Access Compliance Report

Public Rights-of-Way

(Curb Ramps)

Intersection ID: 18104	Main Street: ROBIN_RD	Cross Street: S_SHARON_AMITY_RD	Location: SE
ADA ID: 4400A0830A67	Ramp Type: PerpDiag	Initial Pass/Fail: Fail	Overall Compliance: No
		Severity Score: 35

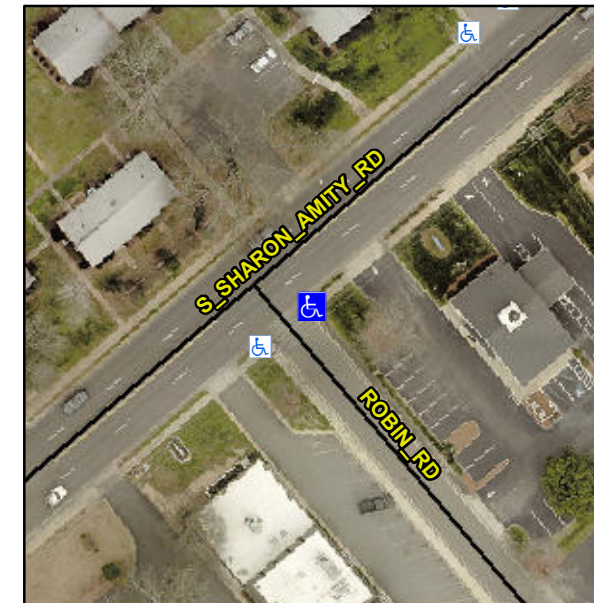
Not Found, R304.5.1, R304.2.2, R304.5.3

Compliance	Description	Data	Compliance	Description	Data
N/A	Ramp Length (in)	54.0	No	Ramp Slope (%)	12.8
No	Ramp Width (in)	39.0	No	Ramp XSlope (%)	2.4
N/A	Flare Type LT	N/A	N/A	Flare Type RT	N/A
N/A	Flare Slope LT (%)	N/A	N/A	Flare Slope RT (%)	N/A
N/A	Flare Traversable LT?	N/A	N/A	Flare Traversable RT?	N/A
N/A	Landing Length (in)	N/A	N/A	DWS Provided?	N/A
N/A	Landing Width (in)	N/A	N/A	DWS Contrast?	N/A
N/A	Landing Slope (%)	N/A	N/A	DWS Length (in)	N/A
N/A	Landing X Slope (%)	N/A	N/A	DWS Full Width?	N/A
N/A	Landing Curb? (Y/N)	N/A	N/A	DWS Offset (in)	N/A
N/A	Shared Landing?	N/A			
N/A	Gutter Ponding?	N/A	N/A	Gutter Slope (%)	N/A
N/A	Gutter Lip Ht (in)	N/A	N/A	Gutter X Slope (%)	N/A
N/A	Painted X Walk1?	No	N/A	Painted X Walk2?	No
	X Walk 1 Direction	To NW		X Walk 2 Direction	To SW
N/A	X Walk 1 Width (in)	N/A	N/A	X Walk 2 Width (in)	N/A
	X Walk 1 Slope (%)	3.5		X Walk 2 Slope (%)	2.1
	X Walk 1 X Slope (%)	2.8		X Walk 2 X Slope (%)	0.7

Remove & Replace Curb Ramp With Two New Directional Ramps or Equivalent.
